# UNITED STATES PATENT AND TRADEMARK OFFICE

APPLICATION NO.	FILING DATE	FIRST NAMED INVENTOR	ATTORNEY DOCKET NO.	CONFIRMATION NO.
10/811,154	03/29/2004	Gabriel Petta	3445-151	1119
1059 7590 06/25/2009 BERESKIN AND PARR LLP/S.E.N.C.R.L., s.r.l. 40 KING STREET WEST BOX 401 TORONTO, ON M5H 3Y2 CANADA				
EXAMINER STRIMBU, GREGORY J				
ART UNIT 3634		PAPER NUMBER		
MAIL DATE 06/25/2009		DELIVERY MODE PAPER

### Office Action Summary

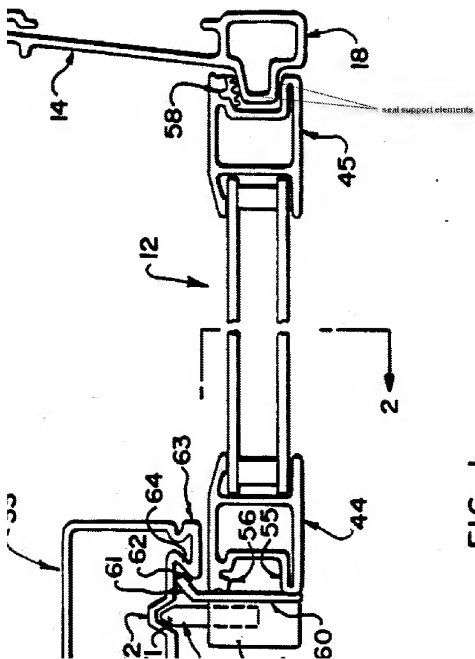
Claim 17 is rejected under 35 U.S.C. 103(a) as being unpatentable over Davies in view of Arbetter (US 5189841). Davies discloses a frame assembly, the frame assembly comprising:

a) a unitary master frame 10 including upper 15 and lower 16 horizontal master frame members, and opposed first 14 and second 13 vertical jamb members extending between the upper and lower horizontal master frame members, and a mullion 33 defined by a vertical member extending contiguously from, and vertically between, the upper and lower horizontal master frame members, the mullion having a vent side (not numbered, but shown on the right hand side of the mullion in figure 1) directed towards the first vertical jamb member 14 and a fixed side (not numbered, but shown in figure 1 on the left hand side of the mullion) directed towards the second vertical jamb member 13;

b) a unitary sash frame 12 slidably mounted within the master frame, the sash frame including upper 46 and lower 47 horizontal sash frame members, and a pair of opposed side members 44 and 45 extending vertically between the upper and lower horizontal sash frame members, the sash frame being slidable between open and closed positions within the master frame; and

c) seal support elements (labeled below) on the master frame for securing seals to the master frame, the seals adapted to engage the sash frame for inhibiting penetration of fluid from an exterior environment to an interior environment when the sash frame is in the closed position.

Davies is silent concerning integrally molding the master frame and the sash frame.

However, Arbetter discloses a method of making a master frame 60 and a sash frame 62 of a window comprising integrally molding the master frame and the sash frame.

It would have been obvious to one of ordinary skill in the art to manufacture the frame assembly of Davies by using the integrally molding method steps, taught by Arbetter, to avoid water and air penetrating the corner joints and to increase the torsional rigidity of the frames.
